## CITYGATE MARKET PLACE JSP15-21

Public hearing at the request of Grand Beck Partners LLC for approval of the Preliminary Site Plan with Retail Service Overlay, Woodlands Permit, Wetlands Permit and Storm water Management Plan. The subject property is located in Section 16, on the southeast corner of Citygate Drive and Beck Road. The applicant is proposing to construct a 6,241 sq. ft. building with a retail space and two fast food restaurant spaces (with associated parking, landscaping and storm water facilities) utilizing the Retail Service Overlay Option. A drive-through is proposed for one of the restaurant spaces.

## PLANNING REVIEW

Review based on Revised Preliminary Site Plan submitted on August 31, 2015

**SITE PLAN**

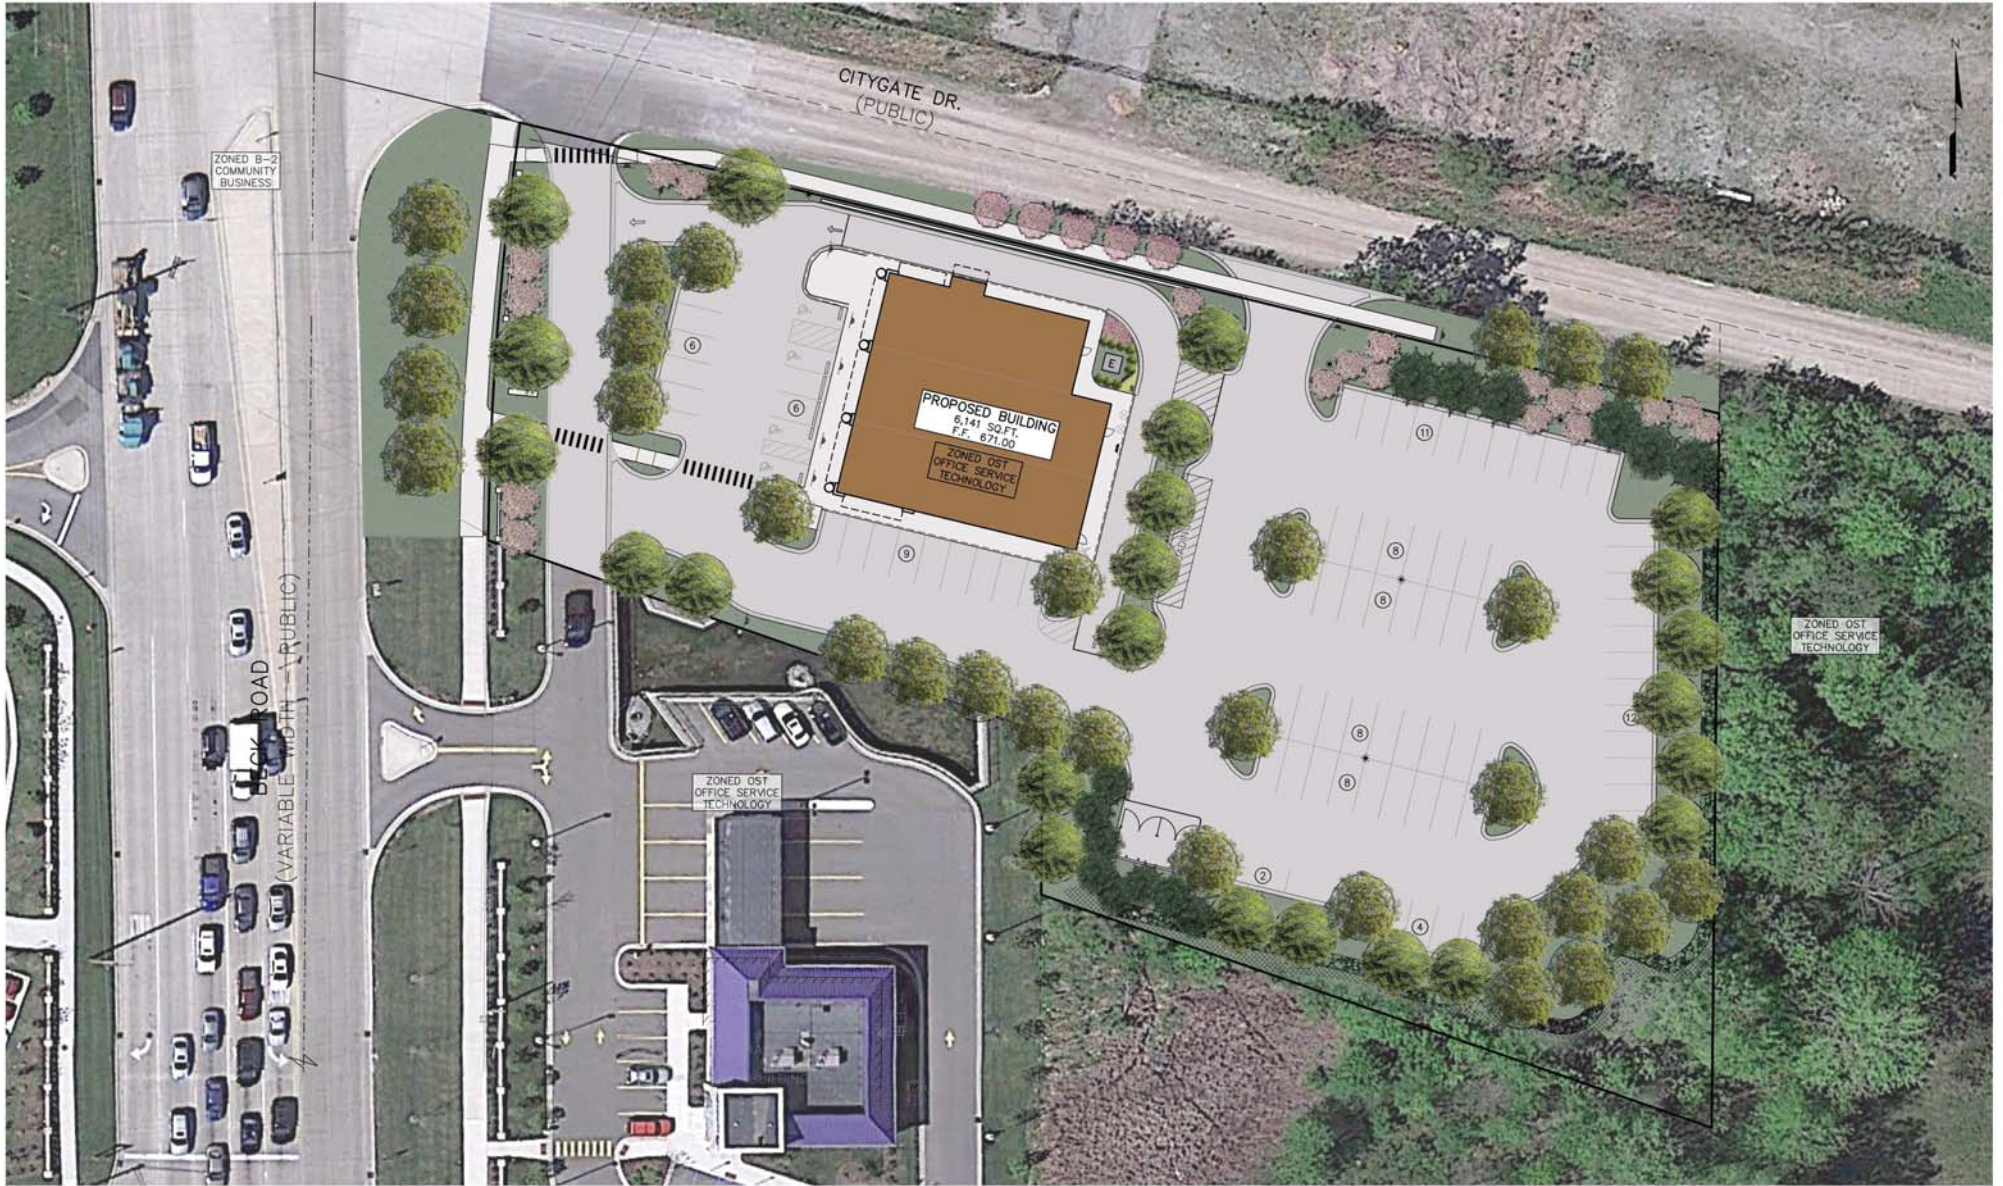
1. Retail Service Overlay: The applicant is utilizing the Retail Service Overlay Option which allows an applicant to develop properties for uses not usually permitted in the OST District. Refer to the planning chart and façade review letter for a general overview of the retail service overlay conditions and the merits of the application under review. **A public hearing to be held by the Planning Commission is required.**

2. Building Setbacks (Sec 3.1.23.D): Buildings in the OST District must be setback 50 feet from all property lines. The plan indicates a 16 foot building setback in the northern yard. **The applicant has indicated they will seek a variance from the Zoning Board of Appeals for this deficiency.**

2. Loading Spaces (Sec. 5.4.1): **Provide the loading and unloading hours of operation.**
3. Signage: Exterior Signage is not regulated by the Planning Division or Planning Commission. Please contact Jeannie Niland (248.347.0438) for information regarding sign permits.
4. Other Reviews:
